**PLANNED UNIT DEVELOPMENT
STAFF REPORT****Date: September 4, 2014****NAME**

Audubon Properties, LLC.

LOCATION4700 & 4960 Dauphin Island Parkway
West side of Dauphin Island Parkway, 580'± North of
Marina Drive North).**CITY COUNCIL
DISTRICT**

CONTEMPLATED USEPlanned Unit Development Approval to amend a
previously approved Planned Unit Development to allow
multiple buildings on a single building site.**TIME SCHEDULE
FOR DEVELOPMENT**

SITE PLAN

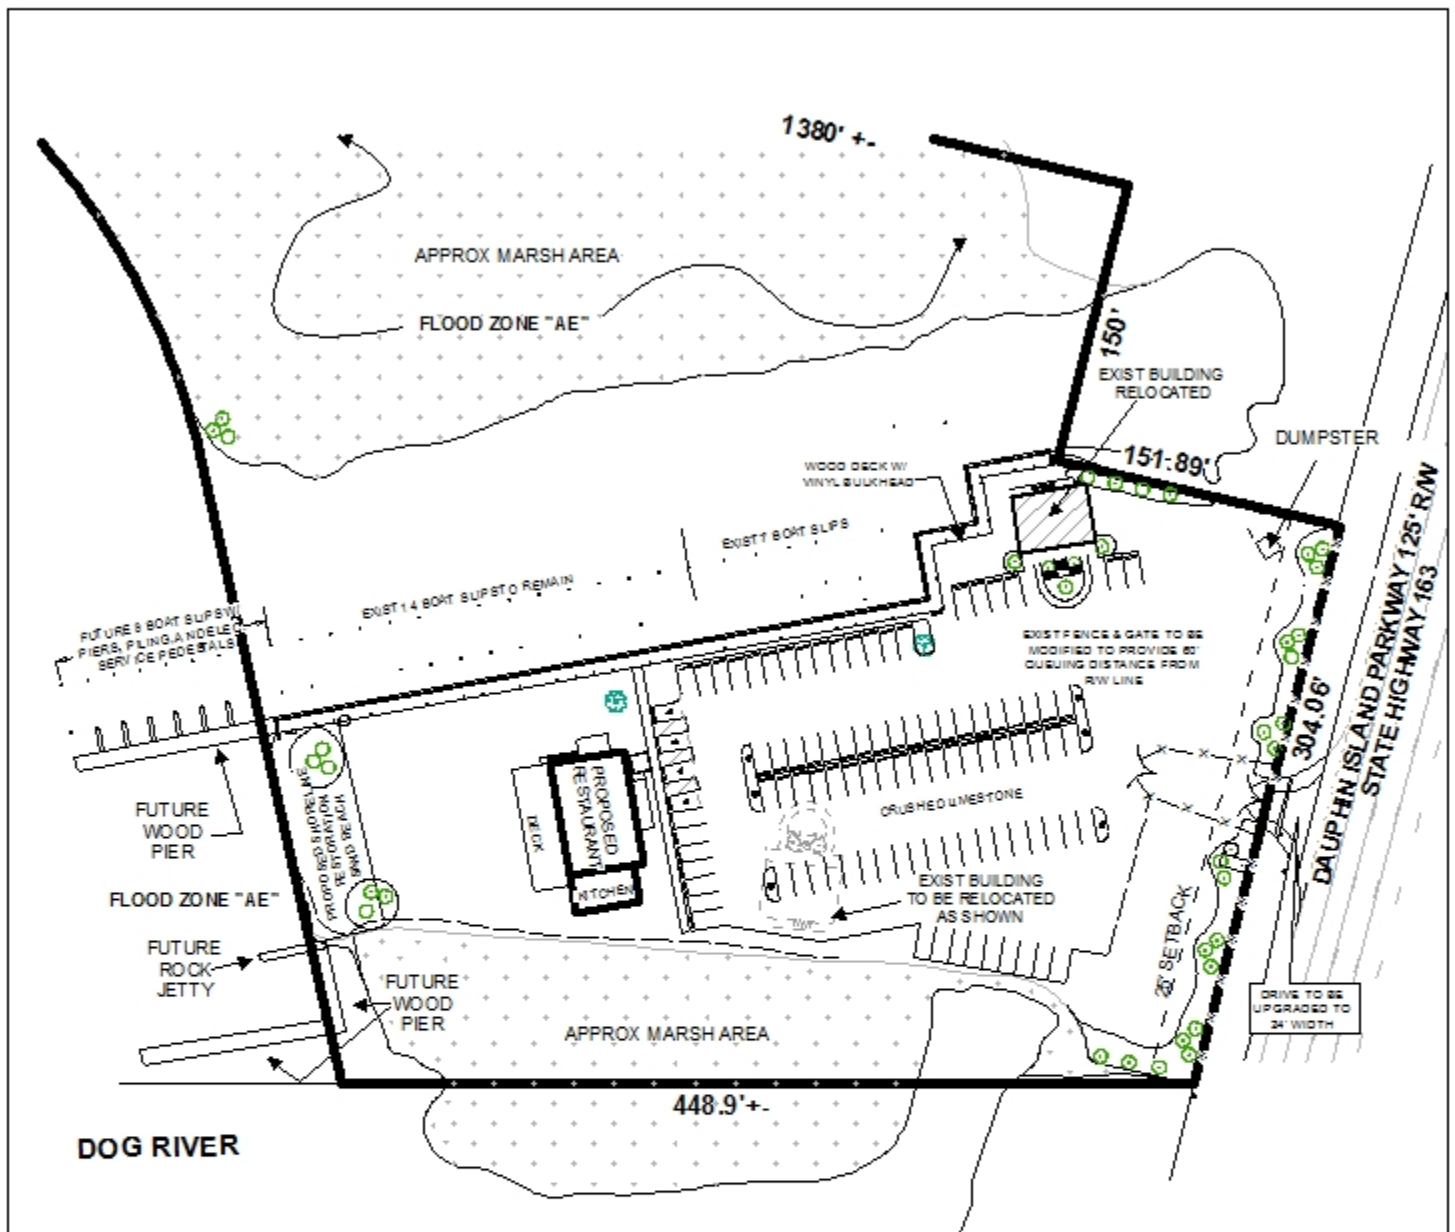
Dauphin Island Parkway is a ALDOT maintained roadway. Driveway number, size, location and design to be approved by ALDOT and Traffic Engineering, and conform to AASHTO standards. The driving aisle in the vicinity of the office building (to be relocated) should be widened to meet minimum driving aisle standards.

It should be pointed out that an aggregate parking surface was allowed through the previous PUD approval when the proposed use was a marina and associated office; however, as the applicant now desires a restaurant-type use, all on-site parking should be paved and in compliance with Section 64-6.A.3 of the Zoning Ordinance.

The proposed restaurant is approximately 4,380 square feet which requires a total of 44 parking spaces. The existing office building is 1,210 square feet which requires 4 parking spaces. The marina requires 15 parking spaces; thus a minimum of 63 parking spaces is required. A total of 97 parking spaces are depicted on the site plan which exceeds the minimum requirements. The site plan also depicts most of the parking spaces with wheel stops, however not all of the spaces depict wheel stops. The site plan should be revised to provide wheel stops for all parking space as required by Section 64-6.A.3 of the Zoning Ordinance. It should also be pointed out that the plan appears to provide 4 accessible parking spaces, one of which is a van accessible space.

The site plan illustrates a dumpster in compliance with Section 64-4.D.9. of the Zoning Ordinance. However, the dumpster appears to be approximately 350' away from the proposed restaurant which causes concern in regards to the efficiency and accessibility of the dumpster in relation to the proposed restaurant. The applicant should consider relocating the dumpster to a more accessible location, or if a second dumpster is to be provided for or by the restaurant it should be reflected on the site plan to verify access and circulation.

- 1) submission of a photometric plan at the time of submittal of a building permit;
- 2) revision of the site plan to depict on-site parking as paved and in compliance with Section 64-6.A.3 of the Zoning Ordinance;
- 3) relocation of the proposed dumpster or revision of the site plan to depict a second dumpster closer to the restaurant;
- 4) revision of the site plan to depict wheel stops or bumper stops on all parking spaces;
